Delegated Report		Analysis shee		Expiry Date:		25/11/2020			
		N	I/A		Consultation Expiry Date:	26/10/2020			
Officer				Application Nu	umber(s)				
Josh Lawlor				2021/2505/P					
Application A	Address			Drawing Numbers					
Flat C 69 Gascony Avenue London NW6 4ND				See decision notice					
PO 3/4	Area Tea	m Signature	C&UD	Authorised Of	ficer Signature				
Proposal(s)									
Proposed roof terrace at 2 nd floor involving the installation of aluminium bi-fold doors, steps, timber privacy screen and back metal handrail.									
Recommend	ation(s):	Refuse Planr	e Planning Permission						
Application Type:		Full Planning Permission

- 1.3. Planning permission is sought for alterations to accommodate the use of the 2nd floor flat roof as a terrace. The new amenity space would be accessed via steps from the loft room. The proposals involve:

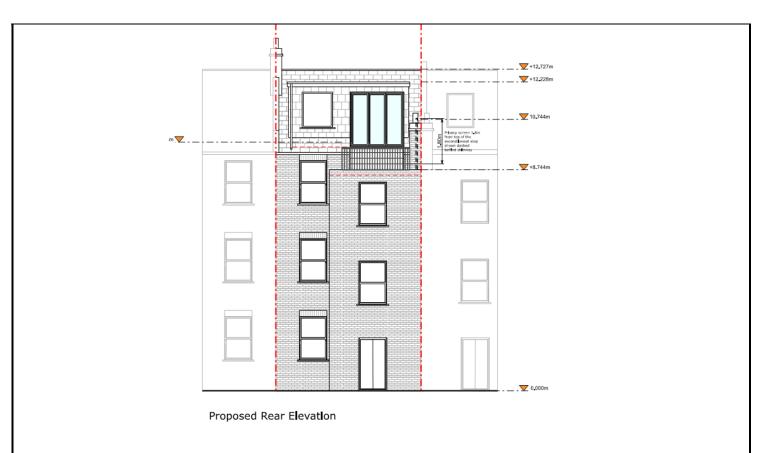
- 3.5. The revisions listed above would reduce the level of harm to the building when compared with the previous proposal, however do not overcome the key design reasons for refusal.

- 3.6. The Design and Access Statement, notes that the steps would be 'inset into the roof pitch and therefore below the eaves line'. It is not clear how this would mitigate the harm previously identified as the stairs would still need to rise above the eaves line to provide access from the bi-fold doors/loft level. This would have the effect of merging the dormer with the rear closet wing. The dormer would no longer be read as a separate and subordinate extension to the host building as the separation from the eaves would be lost. The balustrading, whilst set back would still add visual clutter than would remove the clear separation between the closet wing and the dormer. The dormer would no longer relate to the elevation below as it would essentially sit level/merge with the rear closet wing. The visual impact would be to add excessive bulk and clutter to the rear elevation, undermining the composition of the rear elevation.

- 3.7. The terrace would dominate the roof of the closet wing and not complement the rear elevation. The formation of the terrace would involve the installation of visual clutter. Indeed the seating and planters would all serve to create a cluttered and incongruous appearance which would detract from the host building. To overcome overlooking from the terrace to the dormer windows of 67 Gascony Avenue a 1.8m privacy screen would be installed between the chimney and the dormer wall. This would be visible in oblique views from neighbouring properties on Gascony Avenue and would add additional bulk and visual clutter which would contribute to the harmful appearance of the development. This development, whilst not being visible from the street would be visible in private views. Irrespective of visibility from the public realm, the architectural integrity of the building should be preserved and retained.

- 4.2. The proposed screen would prevent direct overlooking to the dormer windows at 67 Gascony Avenue. The privacy screen would prevent users of the terraces having direct views backwards towards the neighbouring rear dormer window from a distance of approximately 5m. However as discussed above this would add unwanted visual clutter to the building and cannot be supported in design terms.
